PETITION FOR VARIANCE APPLICATION

Name of Owner Mike Slavish	Project Description Renovations and modernization of 12-story (former AT&T) building at to accommodate multiple tenants.	Agent, architect, or engineering firm Dimension IV Madison, LLC
Company (if applies) 316 WWA, LLC		No. & Street 6515 Grand Teton Pl. Suite 120
No. & Street 122 W Washington Ave, suite 350	Tenant name (if any) Multiple future tenants	City, State, Zip Code Madison, WI 53719
City, State, Zip Code Madison, WI 53703	Building Address 316 West Washington Avenue	Phone 608.829.4454
Phone 608.255.5175		Name of Contact Person Ray White, AIA
e-mail mslavish@hovdeproperties.com		e-mail rwhite@dimensionivmadison.com

City of Madison Fire Department Position Statement

Rule Being Petitioned: IBC 1023.5 Elevators shall not open into an exit passageway

FIRST FLOOR DEMOLITION PLAN

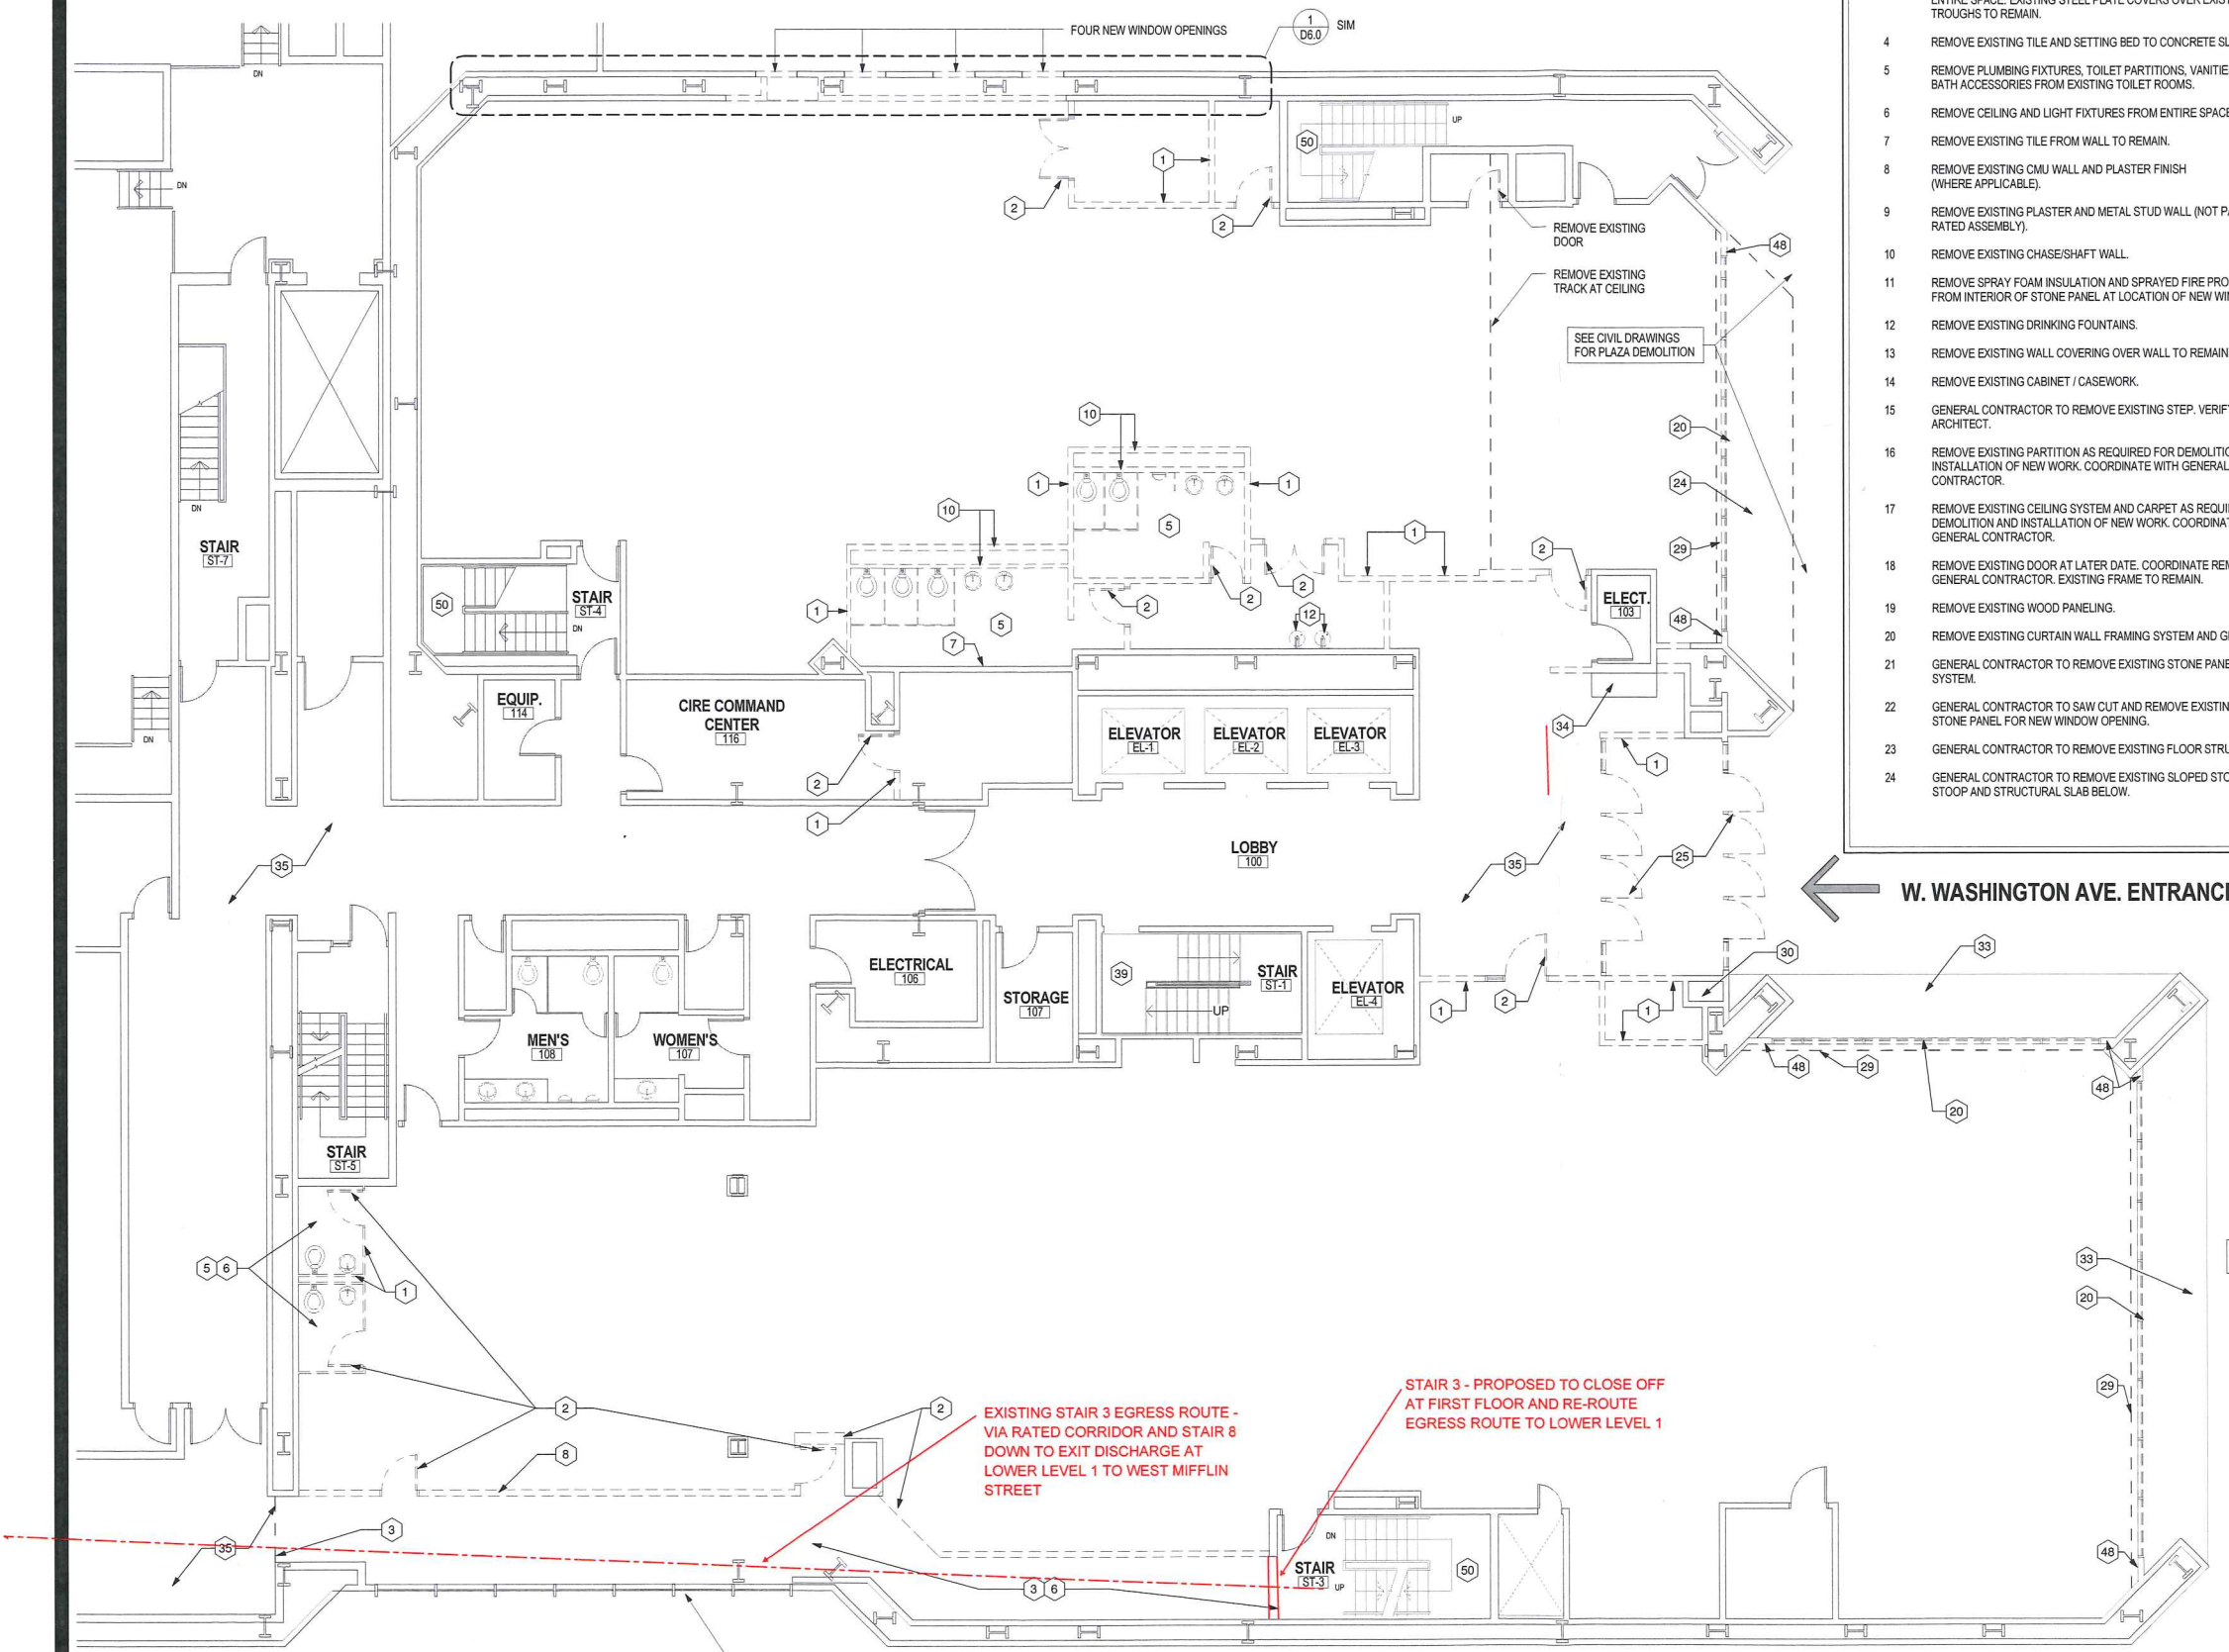
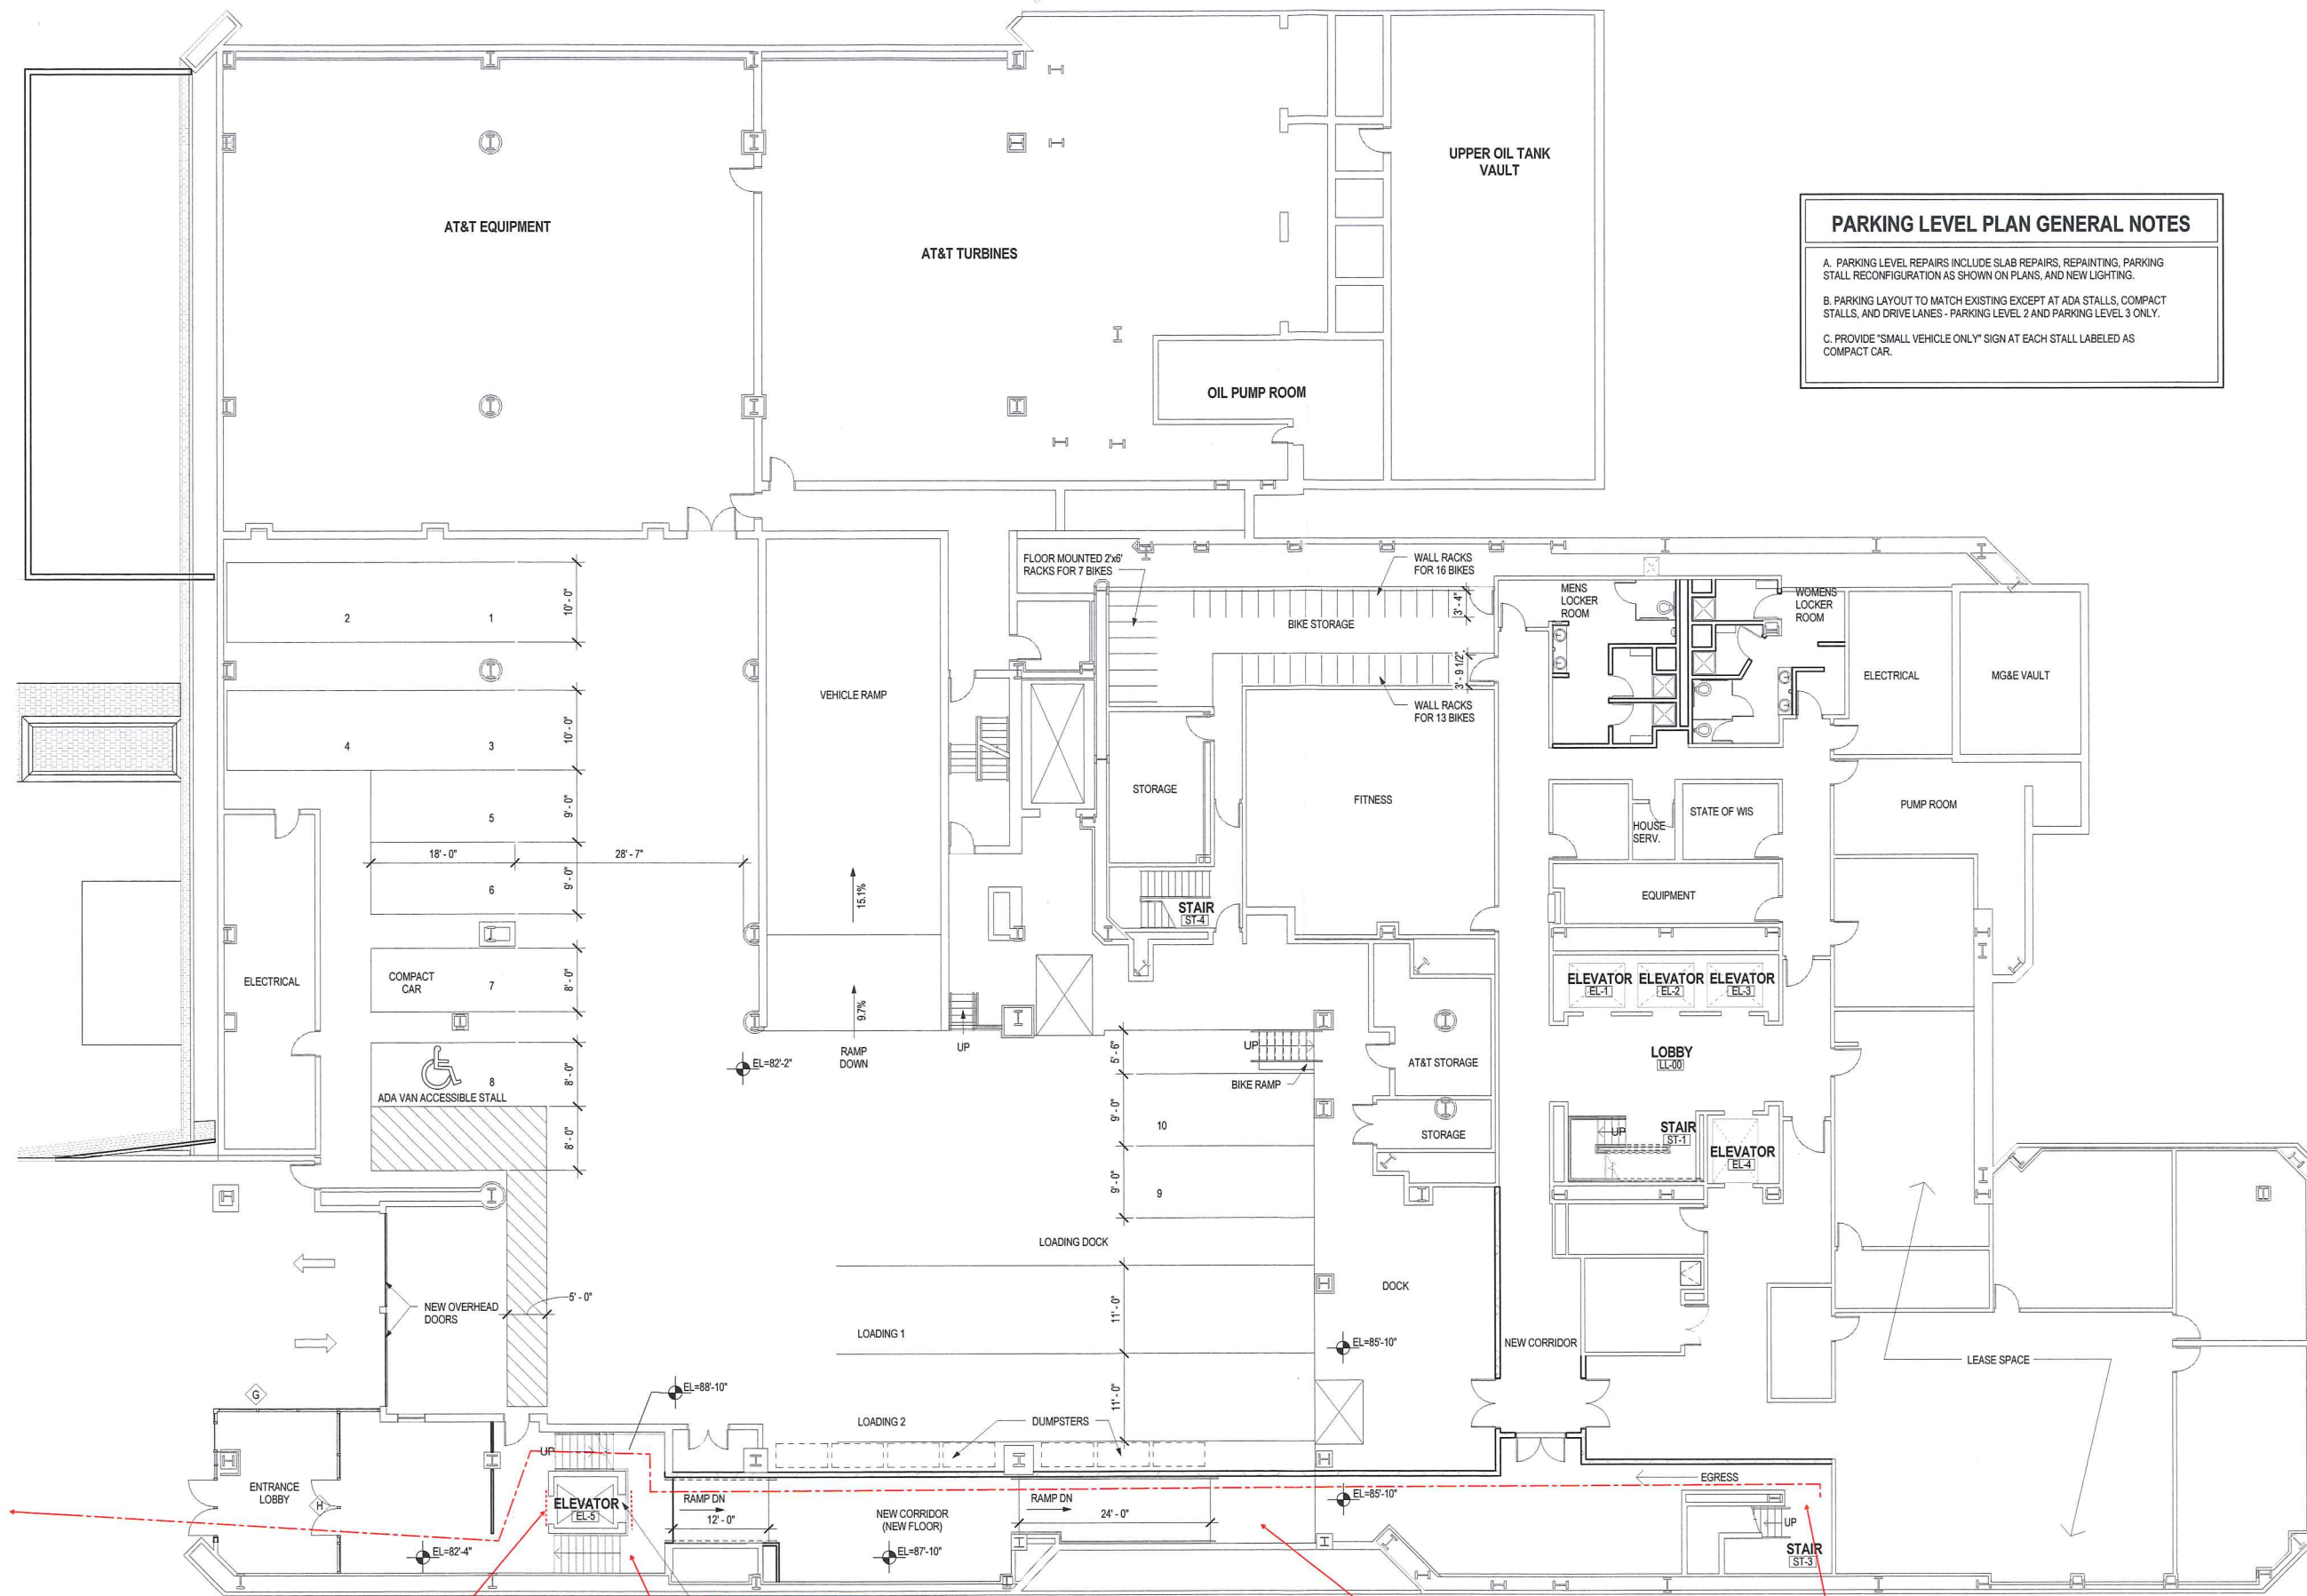
EXISTING STAIR 3 EGRESS ROUTE - VIA RATED CORRIDOR AND STAIR 8 DOWN TO EXIT DISCHARGE AT LOWER LEVEL 1 TO WEST MIFFLIN STREET

STAIR 3 - PROPOSED TO CLOSE OFF AT FIRST FLOOR AND RE-ROUTE EGRESS ROUTE TO LOWER LEVEL 1

1 CODE COMPLIANCE BUILDING SECTION
1/16" = 1'-0"

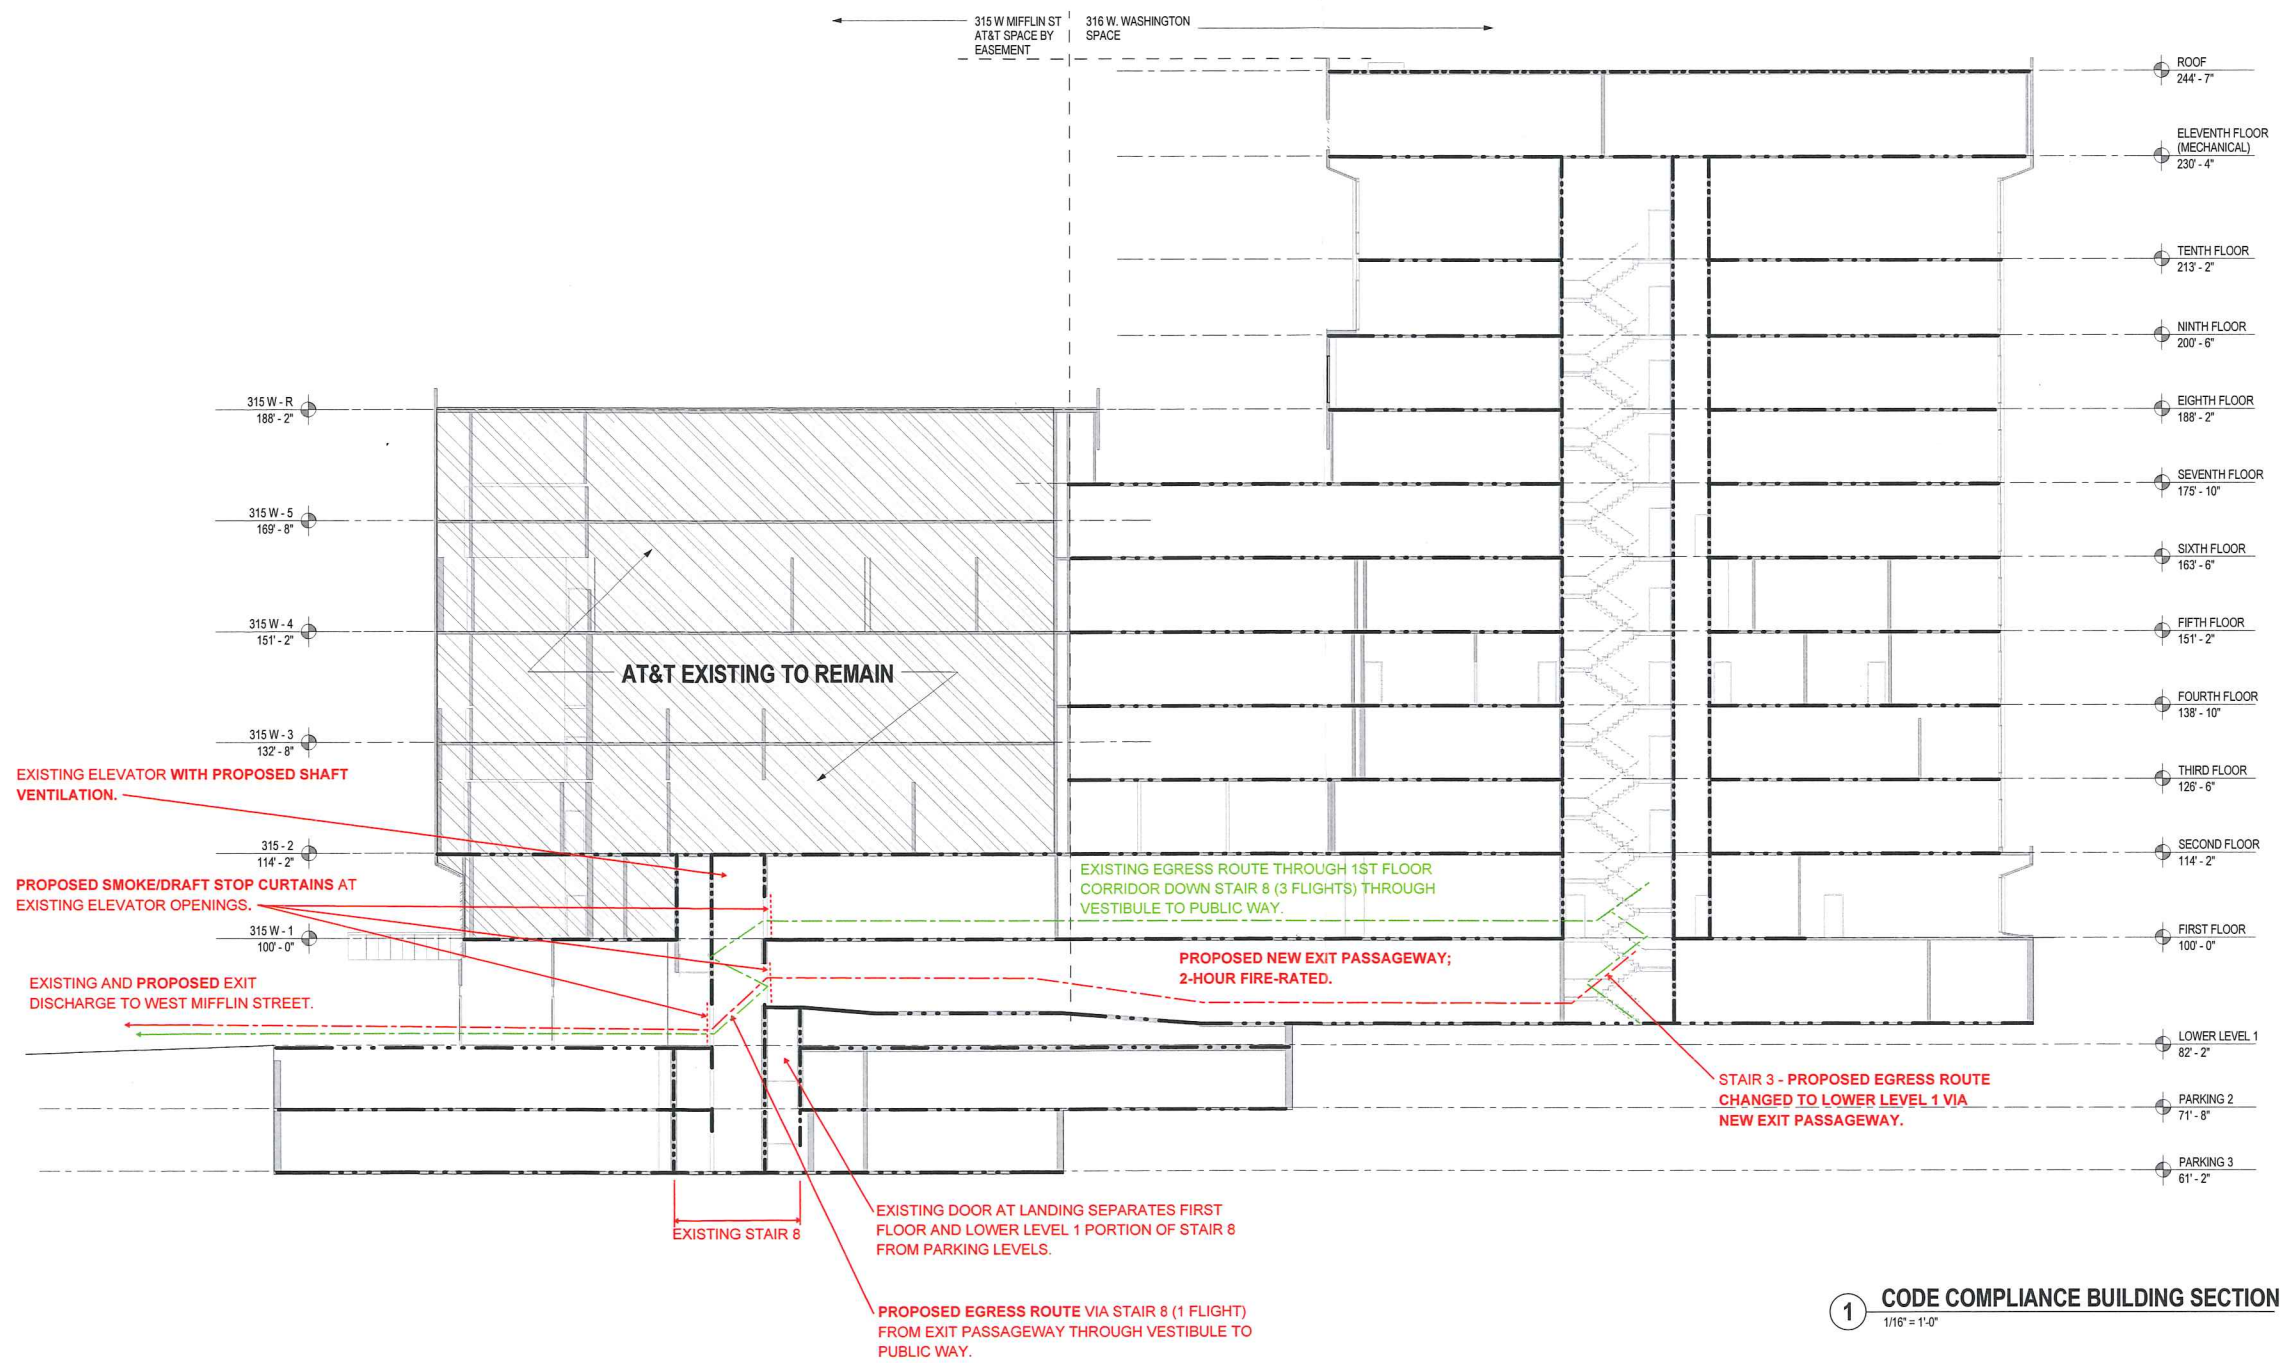
PROPOSED SMOKE/DRAFT STOP CURTAINS AT EXISTING ELEVATOR OPENINGS AT FIRST FLOOR AND LOWER LEVEL 1.

EXISTING EGRESS ROUTE VIA STAIR 8 (3 FLIGHTS) FROM 1ST FLOOR TO 82'-4" VESTIBULE.
PROPOSED EGRESS ROUTE VIA STAIR 8 (1 FLIGHT) FROM EXIT PASSAGEWAY TO 82'-4" VESTIBULE.

NEW EXIT PASSAGEWAY; 2-HOUR FIRE-RATED.

STAIR 3 - EGRESS ROUTE CHANGED TO LOWER LEVEL 1 VIA NEW EXIT PASSAGEWAY1

- The current condition has exiting from Stair 3 over to Stair 8 via a corridor on the First Floor.
- The proposed condition will have exiting from Stair 3 over to Stair 8 via an exit passageway on the lower level.

- The elevator currently opens directly within Stair 8.
- The building is in the process of upgrading the building fire alarm system and extending the fire sprinkler system.

- The applicant proposes adding a smoke guard system to all elevator doors of Elevator #5.
- Elevator #5 will be provided with hoistway venting.
- Exiting is enhanced by traveling through a rated exit passageway as opposed to the current unrated corridor.

- A fire command center shall be established on the first floor level near the W Washington Ave entrance. Fire command center features shall be added as portions are added, replaced, or altered.

- The building fire alarm system shall function as one system with notification of a fire condition throughout the building.
